Administrative Approval Action

5613 Winthrop Drive Subdivision: S-45-18,
Transaction# 568746, DA-113-2018, AA#3883

Design Adjustment Staff Response

Article 8.3 Blocks Lots, Access

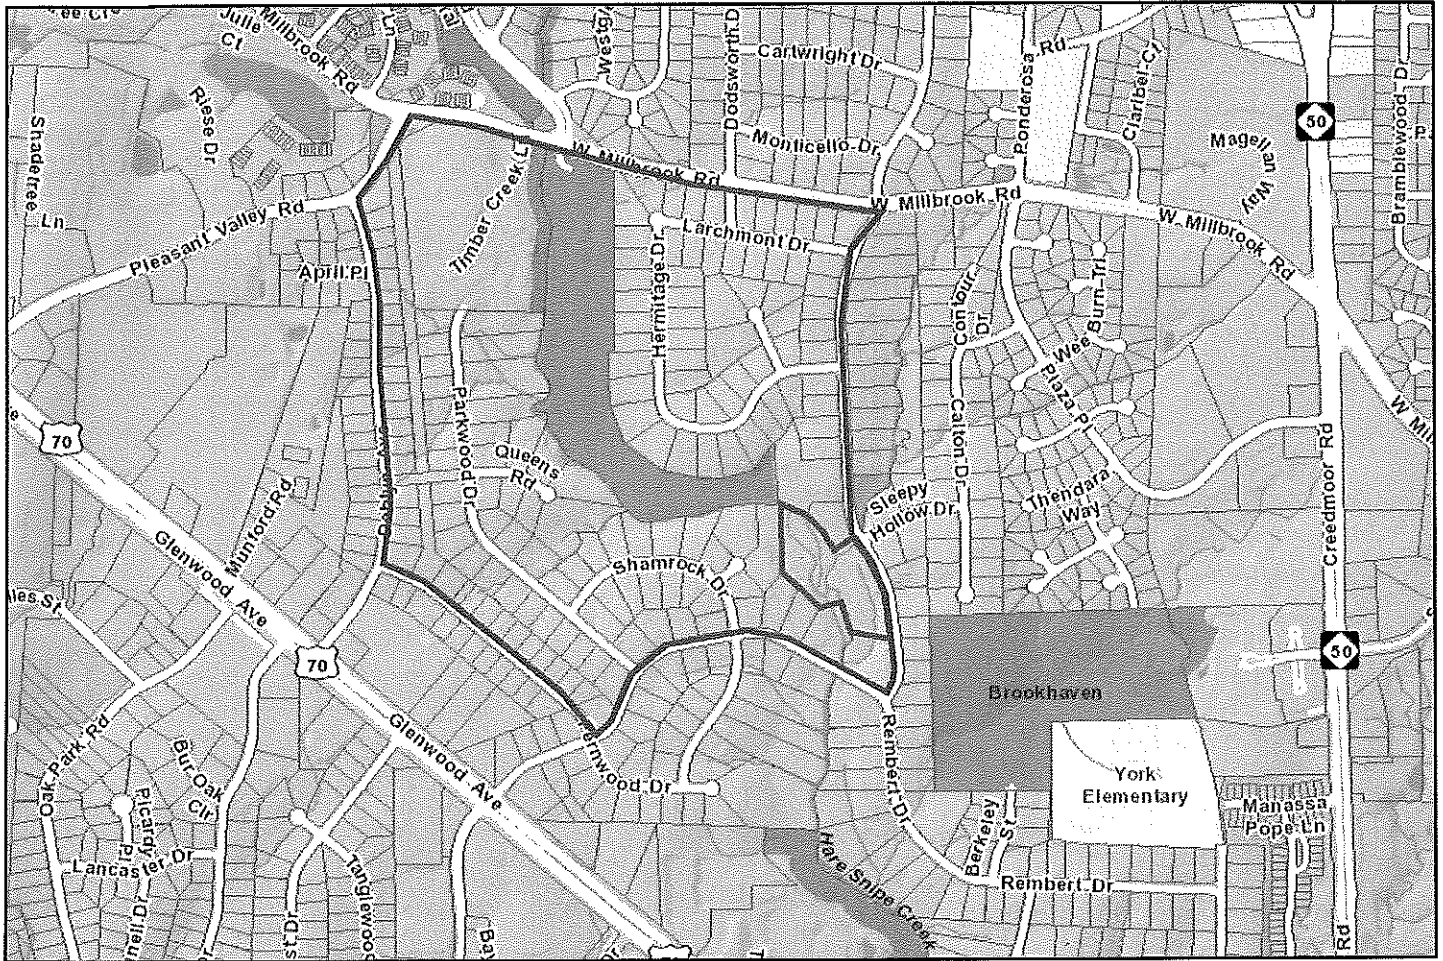
This design adjustment is to request a waiver from the block perimeter requirement to provide a public street access within this site based on the topography, the floodplain of a Neuse Riparian Buffer along Hare Snipe Creek and developed properties to the west and south of this site. The specific block perimeter analysis is within the development application and see the attached plan sheet for limitations of this site.

A petition sidewalk project on the east side of Winthrop Drive is being designed by the City and will provide a more convenient sidewalk access to the sidewalk being constructed along these west side subdivision lots. A new 10' greenway easement is being dedicated to the City within Lot 1 to connect to the existing City of Raleigh 75' greenway easement.

<input type="checkbox"/> Public Utilities			
STAFF RESPONSE	CONDITIONS:		
Development Services Director or Designee Action: <input checked="" type="checkbox"/> APPROVE <input type="checkbox"/> APPROVE WITH CONDITIONS <input type="checkbox"/> DENY
